LAM BOW APARTMENTS

DESIGN RECOMMENDATION #2 REVIEW MEETING

SDCI PROJECT #3029799
RECOMMENDATION MEETING:
DECEMBER 23, 2019

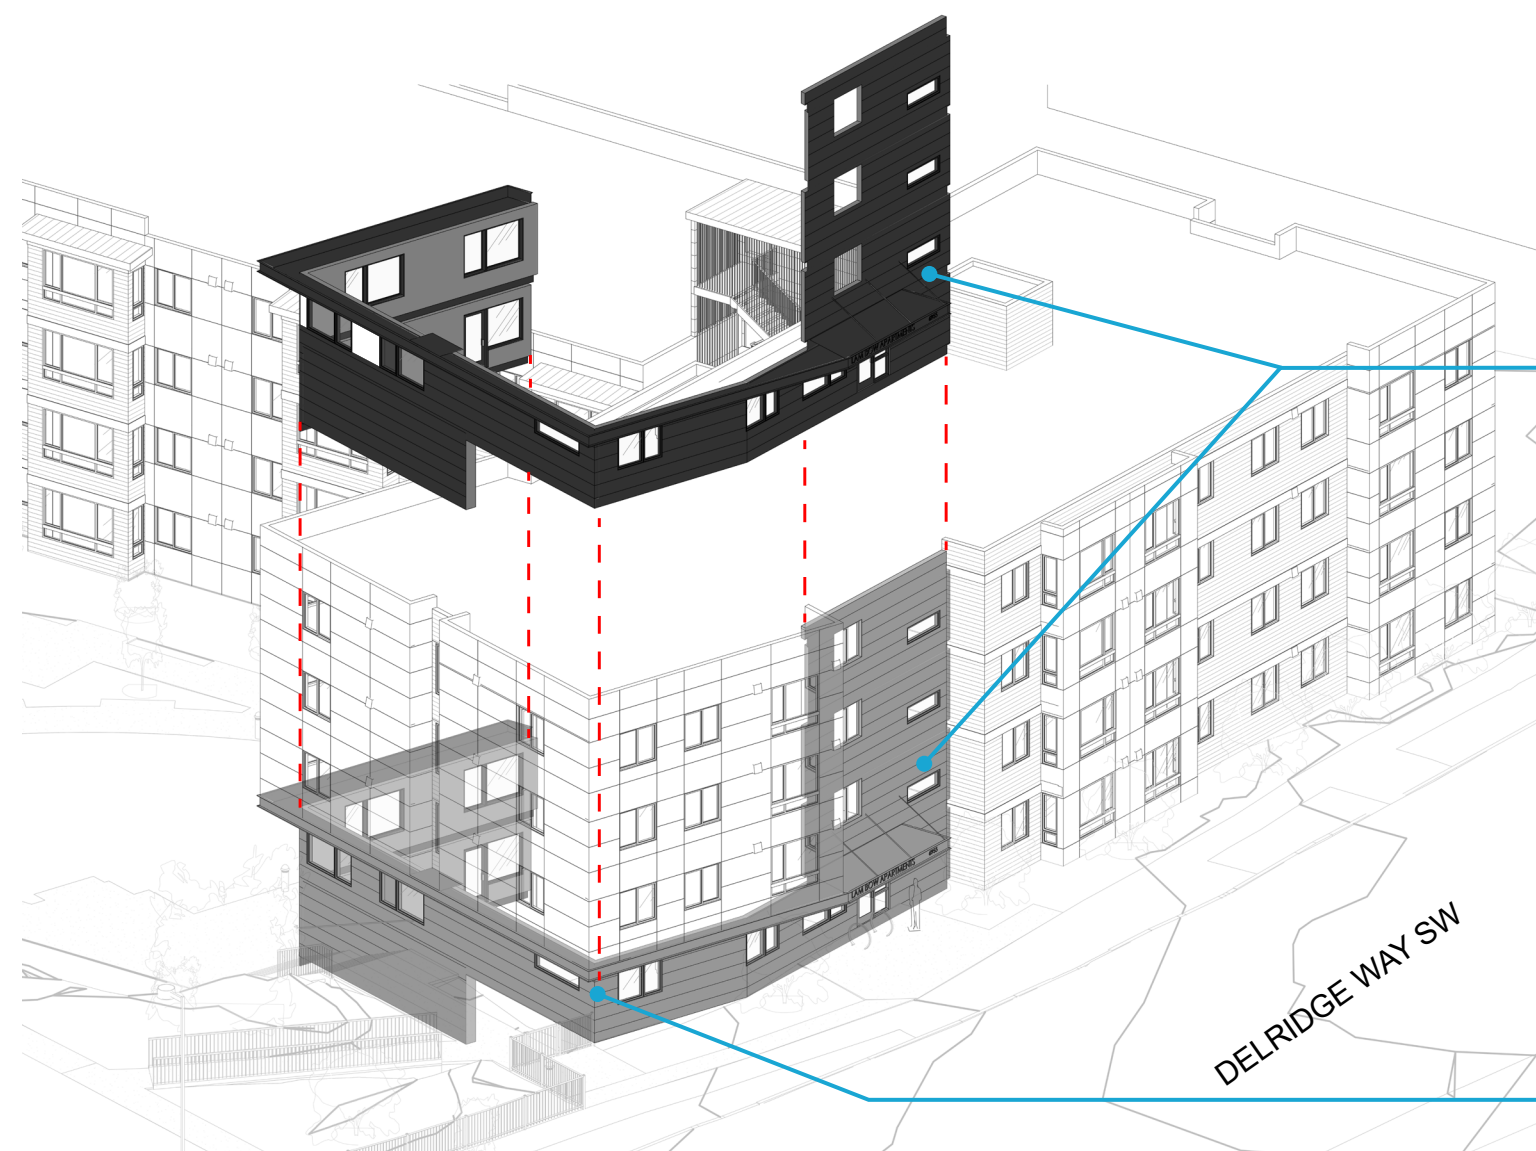
1d. Staff supports the 15-foot setback from the west property line and single family zone, however, the setback alone does not fully mitigate height, bulk and scale concerns along the sensitive zone transition. Incorporate elements that contribute to a small-scale residential character, such as reducing the height of the projecting bays, minimizing the solid parapet, and incorporating individual entries. Staff specifically prioritizes CS2-D-3, Zone Transitions, and CS2-D-4, Massing Choices. (CS2-D-3, CS2-D-4).

2d. Staff notes that the “Small Scale Bay Projections” precedent image on page 25 of the EDG-2 packet also depicts large glazing that breaks up the field and provides visual interest. Staff recommends incorporating large glazing. (DC2-B-1)

RESPONSE: The proposal has been revised to respond to these Design Guidelines (CS2-D-3, CS2-D-4 & DC2-A-2, DC2-C) by incorporating the following at the west and north facades:

Color change and material transition at the fourth floor breaks up the building height to reduce the perceived height and scale better with the adjacent context (CS2-D-3, DC2-A-2).

The massing has been recessed at the corridor in the west façade and a material change occurs, with a lowered parapet, at the west and north elevations to break down the overall massing and reduce the perceived length of these façades (CS2-D-3, CS2-D-4 & DC2-A-2). Per Rec1 comments, additional facade modulation has been incorporated on the 23rd Ave SW elevation.

The bay projections stop below the parapet at the roof joist and the bays are detailed with sloped roofs and small overhangs to introduce detailing found in SF zones (CS2-D-4, DC2-A-2, DC2-C).

Per Rec1 comments, the bays on the west facade stop at level 4.

RESPONSE: Six-pane, large scale glazing provides visual interest at bays. (DC2-B-1).

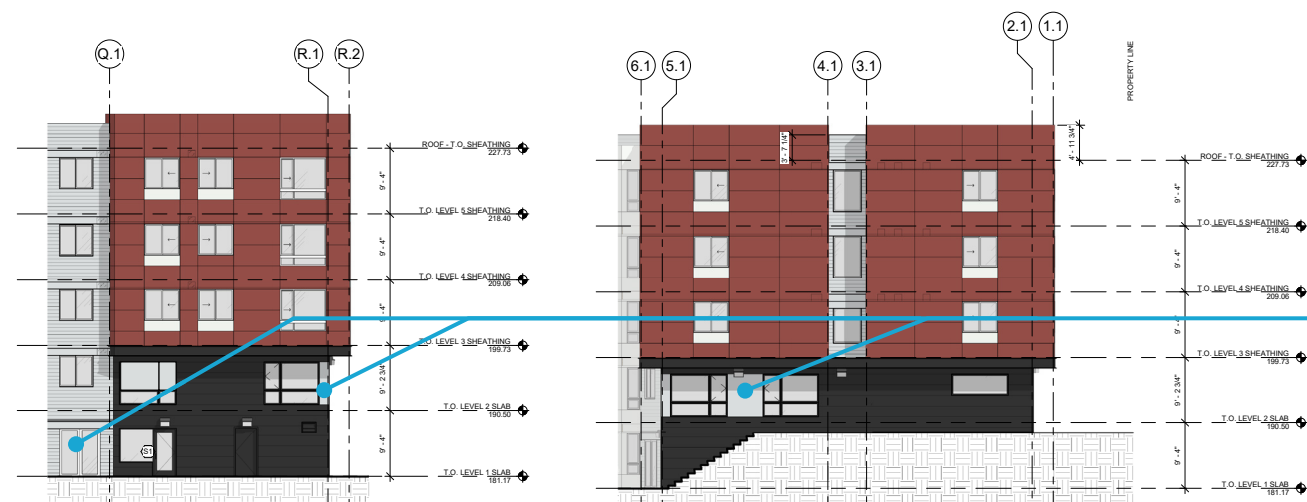
1e. Staff supports the projecting mass above the covered exterior patio as a signature massing move, but is concerned that it is not integrated into the overall architectural expression. Consider how this move may inform the development of the taller portion of the mass along Delridge Way SW, the portion of the mass to the south of the primary residential entry, or the two wings on either side of the courtyard. (DC2)

1f. Staff is concerned about the pinch-point created by the low height of the overhanging mass above the "grand steps" when viewed from Delridge Way SW. Explore lifting the mass in this location. Provide pedestrian eye-level perspectives of this condition at the Recommendation phase. (DC2, DC2-A).

RESPONSE: The massing from the level 1 community room courtyard patio to the level 2 main entry on Delridge Way SW is carved away to reveal a dark material application which continues up to the roof at the building entry. This uniform language highlights the residential common spaces and architecturally defines the main pedestrian entry on the Delridge Way SW frontage (PL3-A-1).

Detailing of the 'carve' includes an angled massing at level 1 and 2, different material application, and a 3'-0" recess from level 2 to level 3 which includes a continuous ledger profile that forms the main entry canopy (PL3-A-2).

RESPONSE: Uniform 3'-0" recess at 'carved' common room areas removes pinch point created from previous covered patio and improves wayfinding by focusing visual interest on the main pedestrian entry on Delridge Way SW.

RESPONSE: Per the Rec1 comments, the glazing at the SW corner of the library/mail room has been increased in height and panels have been incorporated into this facade to provide a ganged appearance to reflect what was shown during EDG. Additionally, a second double door has been added to the L1 community room to further activate the courtyard and connect these spaces.

§2 3D VIEW OF 23RD AVE ENTRY POINT

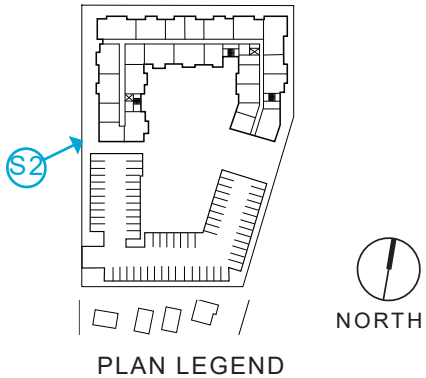
1g. Staff recommends incorporating individual unit entries along 23rd Ave SW and the courtyard to activate these frontages and create a human scale. (PL3-A-3)

RESPONSE: Individual unit entries and patios on 23rd Ave SW and the courtyard were studied but decided against due to the Seattle Housing Authority's policies regarding safety and security of both its residents and the adjacent SF homes. Such unit entries would limit SHA's overall program goals with redevelopment of the site. SHA Property Management cannot consistently monitor and regulate undesirable use of individual entries/unit patios and has had continuous difficulty with these amenity areas being utilized as unsafe and unsightly storage. Additionally, direct unit access to patios inhibits resident's feeling of safety due to the possibility of break-ins from these access points. The number of building access points are kept to a minimum and located in visible areas to emphasize safety and security on site (PL2-B, PL3-A-1).

In response to this item, the 23rd Ave SW street frontage has been developed to improve street-level activation by making the west site access gate a more defined point of entry for visitors and building tenants. The 23rd Ave SW entry will improve wayfinding and incorporate usable site features such as additional bicycle racks, site signage, a seat wall/bench, and artistic textures at exposed site walls (PL1-B-1, DC3-B-3, DC4-D-4). Per the Rec1 comments, a retaining wall was introduced on the 23rd Ave SW frontage to create informal seating area, providing eyes on the street and defining public and provide separation.

§3 SITE SECTION - EAST PARKING LOT TO DERIDGE WAY SW

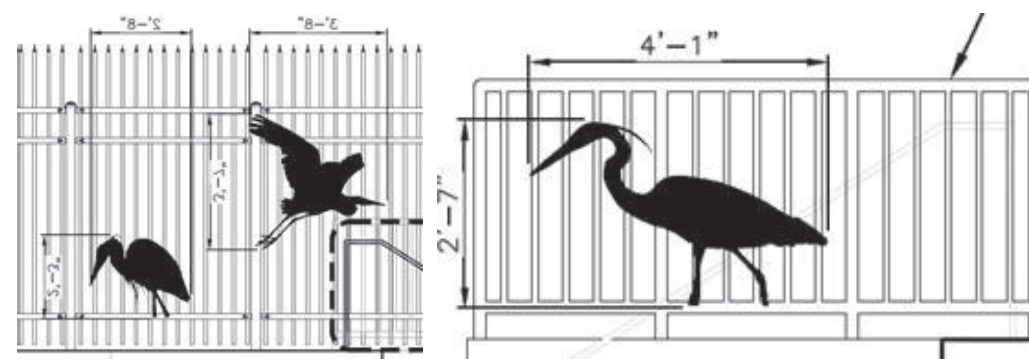
3c. Staff is concerned that the frontage along Delridge Way SW lacks urban character, particularly along the surface parking lot. Explore design solutions that enhance the urban character and pedestrian experience, while also screening surface parking. Consider artistic panels or sculptural pieces. (CS2, CS2-A-1, PL3, DC1-C-2)

RESPONSE: The frontage along Delridge Way SW does not currently have a strong urban character. To enhance the walkability of this street, the parking lot will be screened along Delridge Way SW through landscaping and vegetation. With the high density of traffic along this street, it's beneficial to create a soft, natural edge at this frontage to enhance the pedestrian experience. Additionally, a low picket fencing is proposed along the parking lot to create transparency along the site edges, enhancing safety and security of the site (PL2-B-3). Per Rec1 comments, informational plant labels will be placed along this frontage to provide interest and foster more interaction between the site and passing pedestrians. See page 15 for locations and 39 for renderings of this area.

Per Rec1 comments, artistic imagery of local wildlife or fauna will be placed along this frontage to provide interest and foster more interaction between the site and passing pedestrians. See page 15 for locations and 39 for renderings of this area.

④ 3D VIEW OF GRADE CHANGE AT COURTYARD

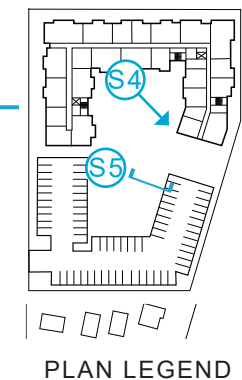
3e. Staff encourages further study of the treatment of the grade change onsite. Avoid large, exposed retaining walls. Explore terracing, sloped landscaping and/or stepped seat walls, which would also help create useable space. Provide sections illustrating the grade change across the site at the Recommendation phase. (DC3-B-1, CS1-C)

RESPONSE: The grade changes across the site have been studied and further developed concurrently with the landscape design. A minimal amount of retaining walls are proposed on site. Instead, steep slopes are mitigated through the use of landscaping, plantings of various heights, terracing grades, and low retaining walls which double as amenity space seating.

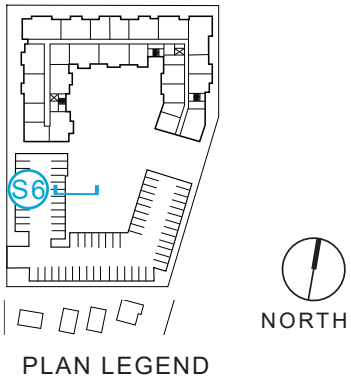
3f. Staff is concerned about the proximity of the children’s play area to the surface parking lot. Provide more information, including sections, on the transition from the parking lot to play area at the Recommendation phase. Provide a rationale as to why the ultimate location of the play area is preferred. (DC1, DC3-B-1)

RESPONSE: The team studied multiple locations for the play area, including further north within the building courtyard. The current location is preferred for the following reasons:

- Structured play areas tend to get very loud, the exposed location doesn’t allow for sound to reverberate off the building, creating more pleasant exterior spaces for all residents.
- It provides more sun exposure, especially in the evening, than if located further north or closer to the main building.
- Locating structured play on the south parcel allows more 'breathing room' within the courtyard of the building and creates another focal point at the south end of the site.

Providing a safe and protected play space is important to the Seattle Housing Authority. Landscaping with a continuous fence will be provided between the parking lot and play area to create a physical barrier and green buffer to protect tenants and children.

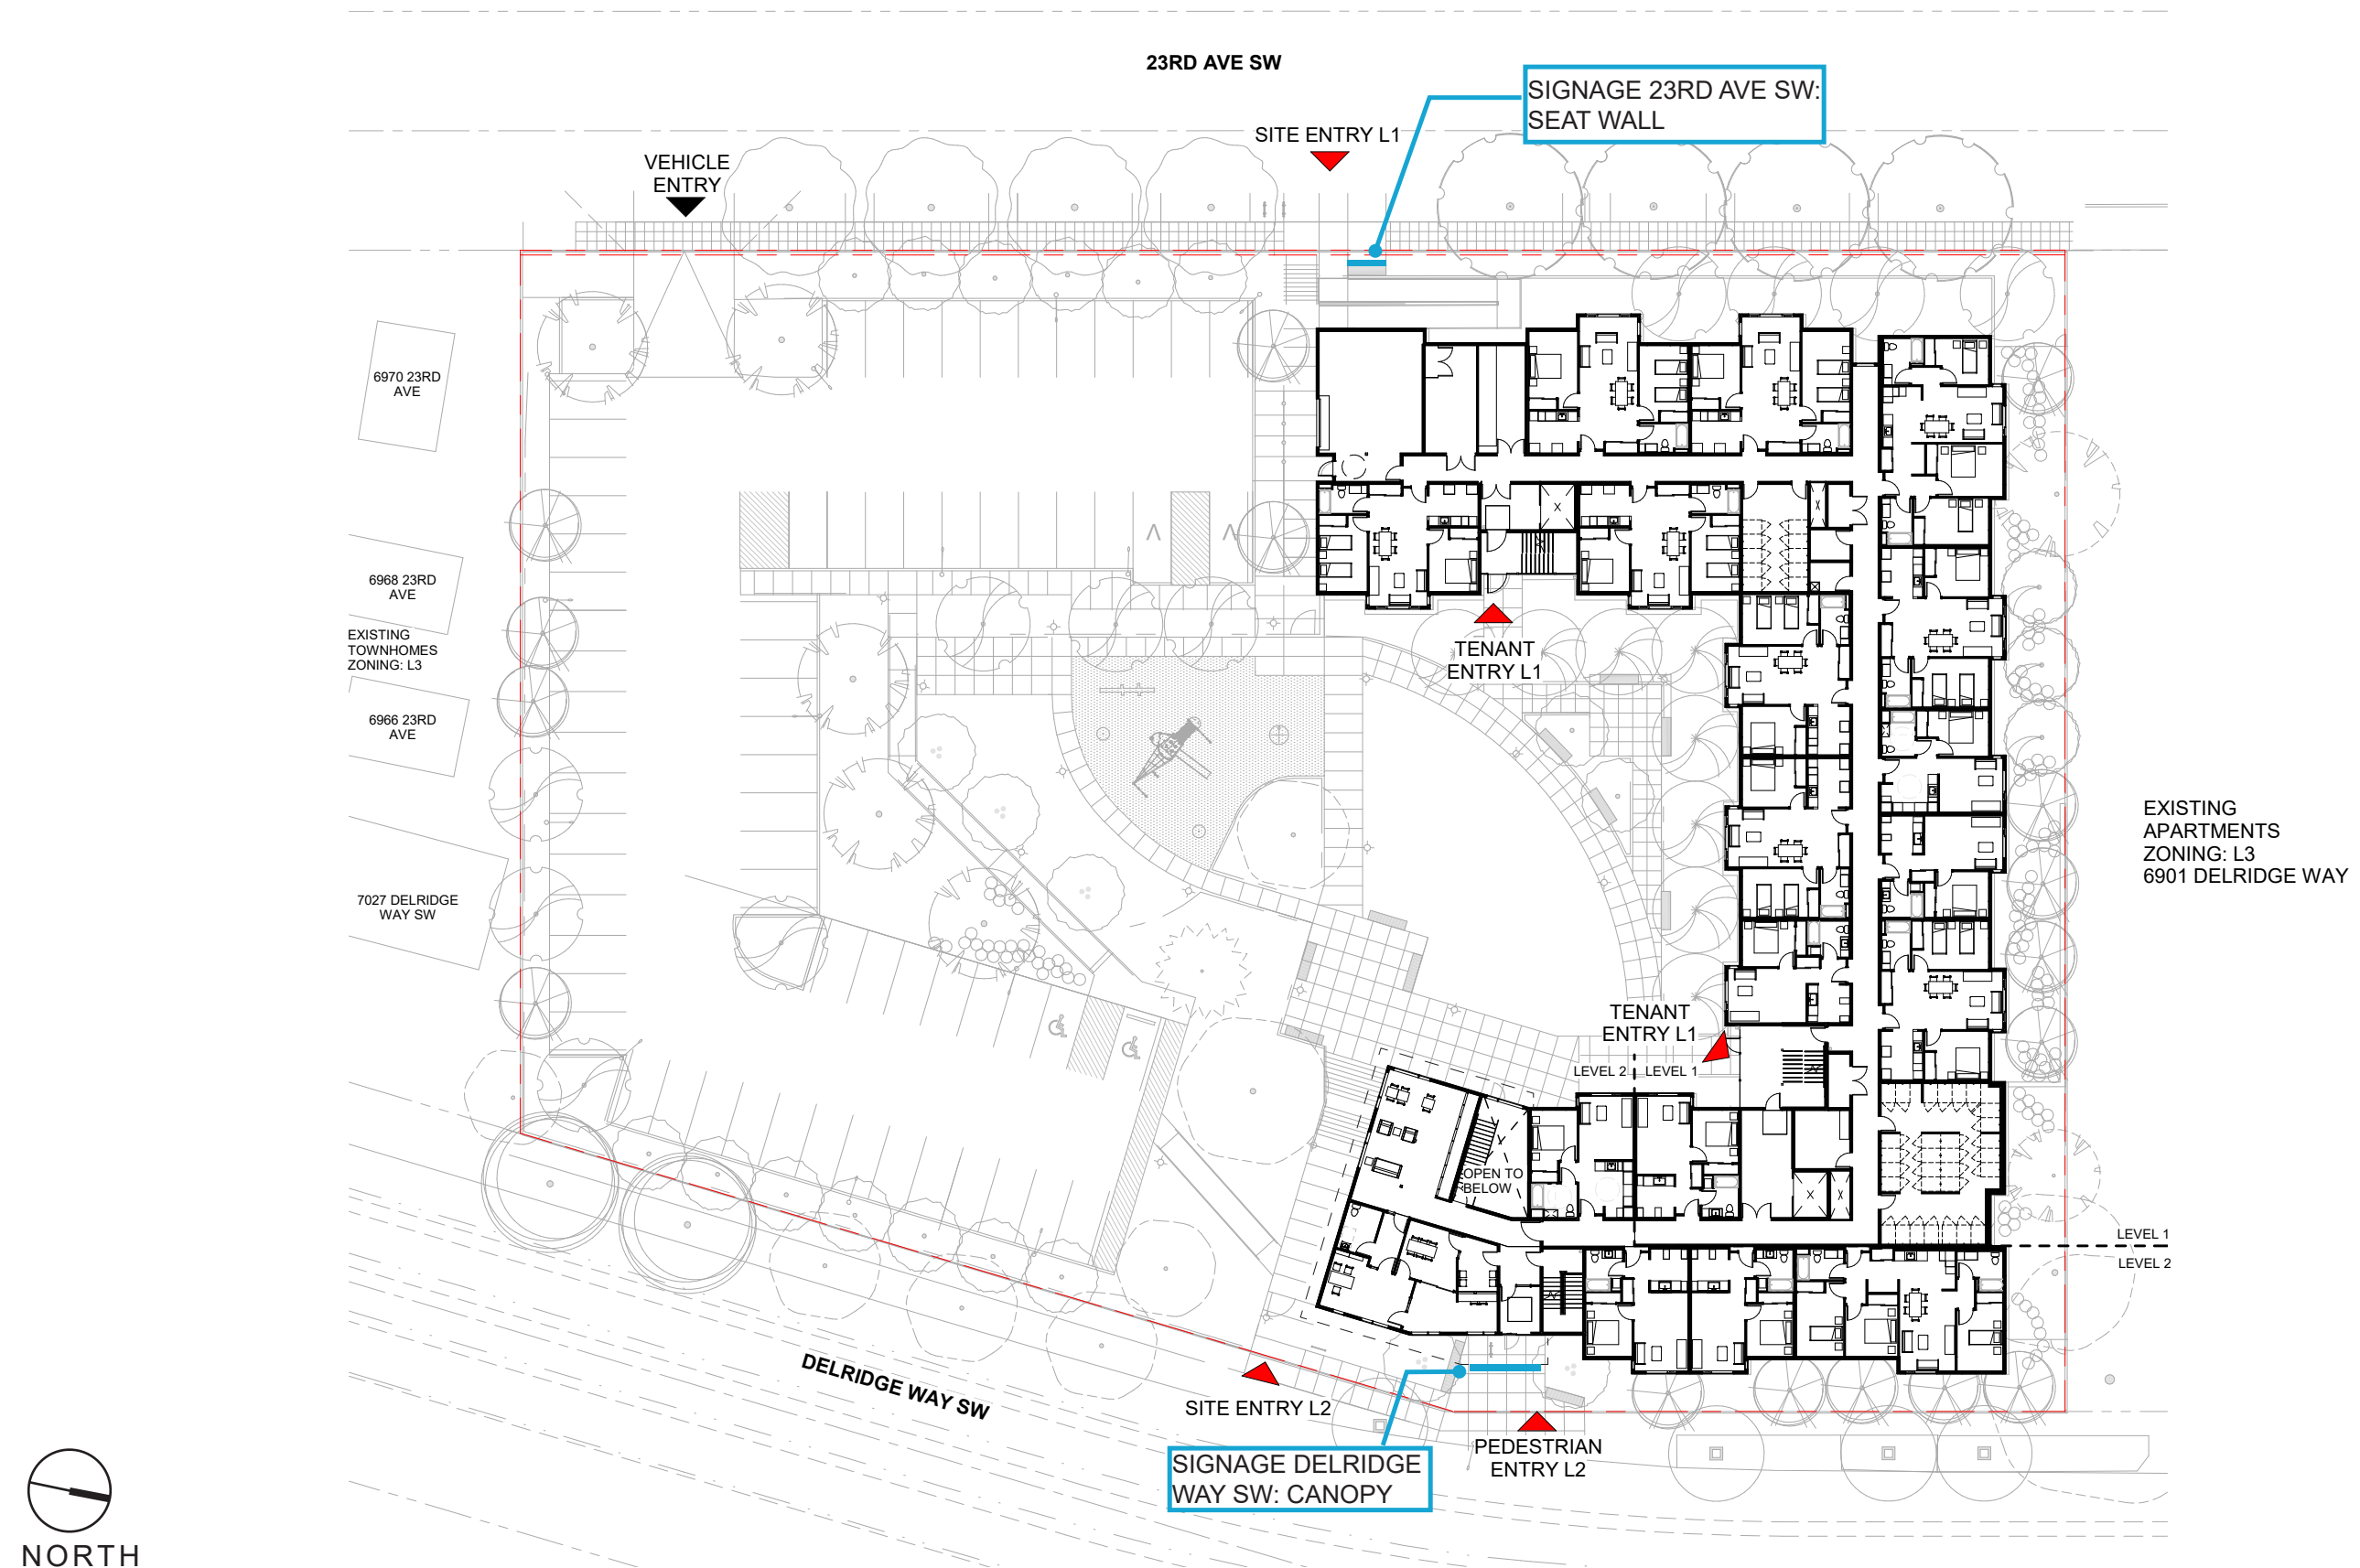
6a. Staff states that lighting should be considered as a feature that has the potential to contribute to a human scale. Lighting should be well integrated into the open space design. Provide a lighting plan at the Recommendation phase. (DC4-C)

RESPONSE: See [page 42](#) for site lighting plan.

RESPONSE: Lighting will only be directed on site to minimize impacts on adjacent residential sites. Indirect pole lighting is proposed to reduce light intensity and glare, see [page 43](#) for fixtures to be used.
